Access Compliance Report

Public Rights-of-Way

(Curb Ramps)

Intersection ID: 31624	Main Street: BRADFORD_DR	Cross Street: THOMASBORO_DR	Location: SE
ADA ID: DE77A6057651	Ramp Type: Perp	Initial Pass/Fail: Fail	Overall Compliance: No
Severity Score: 42.5			
Codes/Mitigation Info/Possible Solution		Field Measurements/Component Compliance

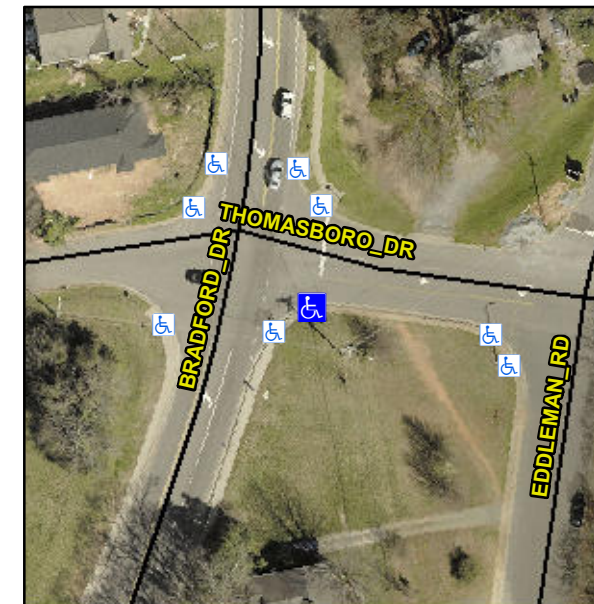
Not Found, R304.5.1, R304.2.2

Compliance	Description	Data	Compliance	Description	Data
N/A	Ramp Length (in)	37.0	No	Ramp Slope (%)	13.1
No	Ramp Width (in)	32.0	Yes	Ramp XSlope (%)	0.5
N/A	Flare Type LT	N/A	N/A	Flare Type RT	N/A
N/A	Flare Slope LT (%)	N/A	N/A	Flare Slope RT (%)	N/A
N/A	Flare Traversable LT?	N/A	N/A	Flare Traversable RT?	N/A
N/A	Landing Length (in)	N/A	N/A	DWS Provided?	N/A
N/A	Landing Width (in)	N/A	N/A	DWS Contrast?	N/A
N/A	Landing Slope (%)	N/A	N/A	DWS Length (in)	N/A
N/A	Landing X Slope (%)	N/A	N/A	DWS Full Width?	N/A
N/A	Landing Curb? (Y/N)	N/A	N/A	DWS Offset (in)	N/A
N/A	Shared Landing?	N/A			
N/A	Gutter Ponding?	N/A	N/A	Gutter Slope (%)	N/A
N/A	Gutter Lip Ht (in)	N/A	N/A	Gutter X Slope (%)	N/A
N/A	Painted X Walk1?	No	N/A	Painted X Walk2?	N/A
	X Walk 1 Direction	To N		X Walk 2 Direction	N/A
N/A	X Walk 1 Width (in)	N/A	N/A	X Walk 2 Width (in)	N/A
	X Walk 1 Slope (%)	0.1		X Walk 2 Slope (%)	N/A
	X Walk 1 X Slope (%)	0.6		X Walk 2 X Slope (%)	N/A

Remove & Replace Entire Ramp.
